**RE: DEVELOPMENT APPLICATION DA2023/0998  
ALTERATIONS & ADDITIONS TO FSLSC**

We refer to the Council RFI letter of 16 November 2023 regarding a list of issues identified in the preliminary assessment of this development application, the Internal Referral reports available via the Council website, Council email of 9 October 2024 regarding the additional responses received from the independent planner and Council heritage advisor, and our Teams meeting held 24 October. On behalf of Freshwater Surf Life Saving Club, we have prepared further supporting information and amendments in response to the issues raised.

View of northeast elevation showing timber shade screens and existing roof line over.

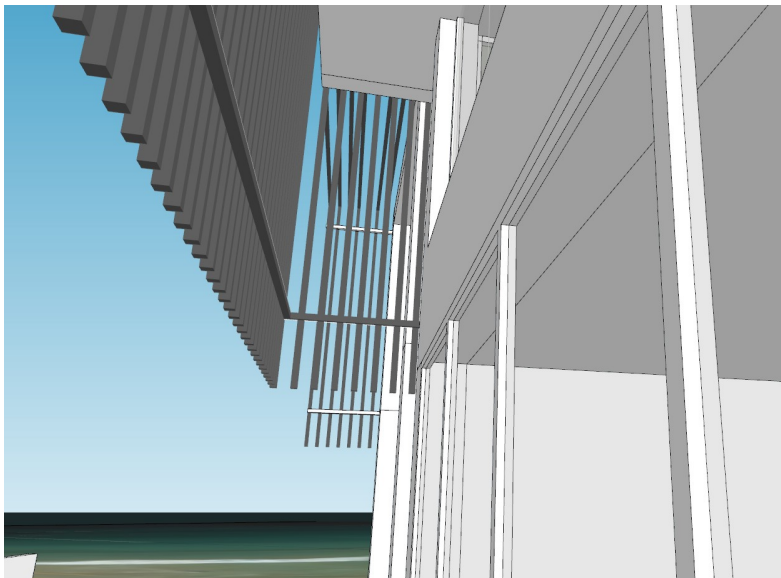
**However, the balustrade needs to be timber, as does the balustrade to the member's terrace. Metal/steel is inappropriate for this heritage building.**

**Apparent width of the building when viewed behind the heritage section is still too wide. This impact can be reduced by pulling in the timber screen eaves to the north and south to the building line and simultaneously reducing the extent over the north and south verandahs.**

- The existing timber balustrades installed to the balcony of the 1935 building as part of the 1986 building works are retained, and this timber balustrade design is now repeated to the Member's Terrace.

- Regarding pulling the timber screen to the building line, the timber shade screens proposed align to the north and south with the existing roof plan, including the existing eaves line over. This location for screens provides sufficient space between timber screen and window glazing to provide shading from sun, shelter from breezes, will allow windows to be openable and provide sufficient space for cleaning and maintenance. We disagree with the comment suggesting the timber screen should be reduced to be flush with the building line, as this would prevent all the above. The proposed location of the timber shade screens relative to the external wall and roof eaves over is as shown in the image below.

View of North Veranda shading and glazing to northeast elevation of MoS

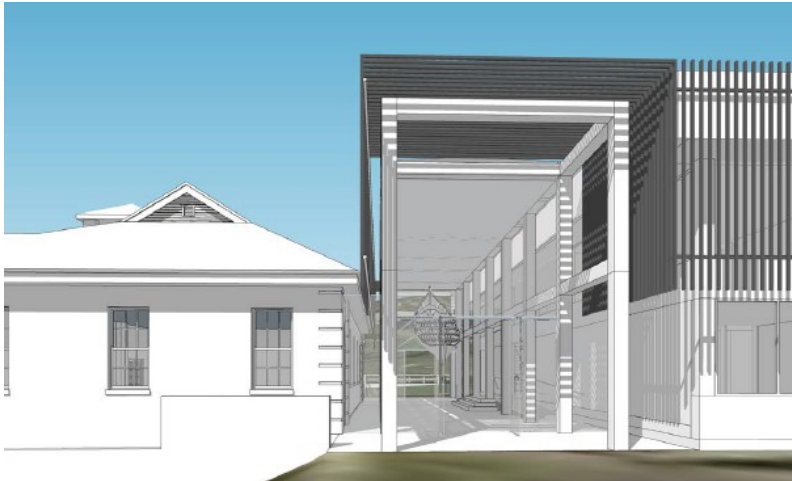
**Additionally, there were discussions about maintaining the visibility of the eastern elevation of the original clubhouse. The proposed design obstructs the view of the eastern façade.**

- We also disagree with the comment suggesting a reduction in the north and south verandas is required. In the current design, the length of the Museum of Surf (MoS) matches the length of the 1935 building, and the width of the north and south verandas matches the width of the adjoining 1986 building, thereby providing an appropriate transition of built form from one to the other.
- Further, the MoS cannot be reduced in area due to the number and volume of heritage artifacts available for display.

- Further, the MoS has been designed for maximum transparency via extensive glazing to allow the 1935 building to be visible “in-the-round”, and to reference the former location of the coastal walk circa 1935. The verandas proposed at either end of the MoS, and the timber shade screens, provide this glazing with shade from northeast and southwest sun. As excessive UV and sunlight will adversely affect any artifacts displayed in the MoS, the verandas are required to provide protection of heritage artifacts and shelter for visitors at entry. The shading provided to the MoS glazing by the North Veranda is as shown in the image below.

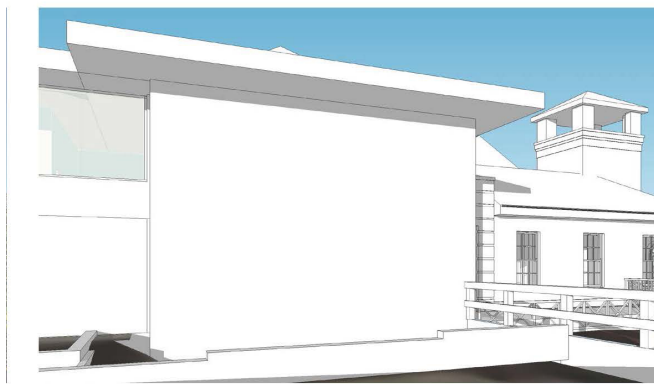
**The proposed additions result in a building with excessive bulk and scale. The increase in the building envelope is substantial, extending 6m to 12m to the west resulting in an increase to the building footprint of approximately 235m<sup>2</sup>. This is contrary to the frequent claims in the Statement of Environmental Effects (SEE) that the proposal has a built form with a similar envelope and footprint to the existing building. The proposed development is substantially increasing both the building envelope and the building footprint. The proposal is inconsistent with the objectives of Clause D9 Bulk and Scale of Warringah Development Control Plan (WDCP) in that;**

- **The design presents as a large high box with a dominating visual impact on the surrounding public recreational parkland and the coastal environment. Some shaping to the corner void elements behind the original building and western end (including the void), in sympathy with the original roof angles / pitch would assist to remove bulk & scale.**

- **The visual impact of the development has not been minimised, with the numerous voids, large roof overhanging the west verandah, the timber batten screen surrounding the north, south and west elevations, additional badminton court, large gymnasium, the 163-seat restaurant, plus a separate 62-seat café all contributing to a community facility with excessive bulk and scale.**

- The northwest extent of building envelope proposed has been significantly reduced.
- At level 1 the building envelope is unchanged from the existing 1986 building.

- At level 2 the proposed extension to the west has been deleted. The roof area proposed provides cover to an existing Club Terrace area. The existing Café Kitchen and Storerooms have been removed. Together, these design proposals provide a Western Veranda and activate the connection between the Club and Freshwater Reserve. Beneath this roof, the fully enclosed covered area proposed for the western end of level 2 is less than the currently existing Club premises. The café has been deleted, and the revised design proposes only one food and beverage venue located in a similar location to the existing café.

- At level 3 the Gymnasium is retained. However, the Gymnasium has been "telescoped" within the building envelope to reduce bulk and the Multi-Purpose Hall below has been reduced accordingly.

- The additional badminton court has been deleted from the design.

Site location of proposed amenities building

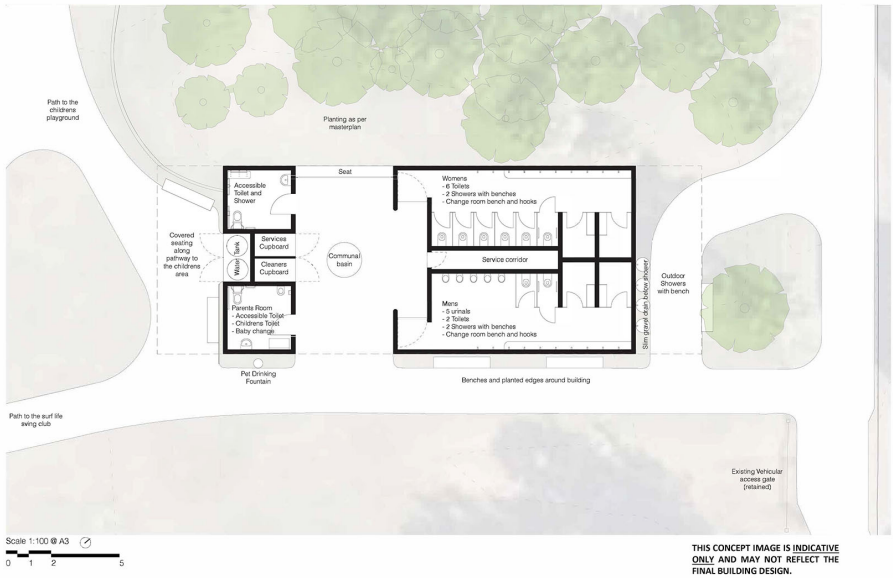
***The amended proposal appears to be generally in accordance with the zone objectives. However, will require evidence of the approval new public amenities before supporting the removal of the existing public amenities from the existing clubhouse.***

***The masterplan labels the outline of the new amenities building as 'future works'. More certainty is required or perhaps this can be addressed by condition of consent requiring the construction of the public amenities before works can commence on the SLSC.***

- The new public amenities are a current Northern Beaches Council (NBC) project, and we understand that the proposed FSLSC works cannot proceed until the existing public amenities have been replaced. The Concept Design for these new amenities is presently available via the NBC website and is illustrated below for convenience.
- An appropriate condition of consent could require the existing public amenities within the FSLSC building to be maintained until the new public amenities are commissioned and in use.
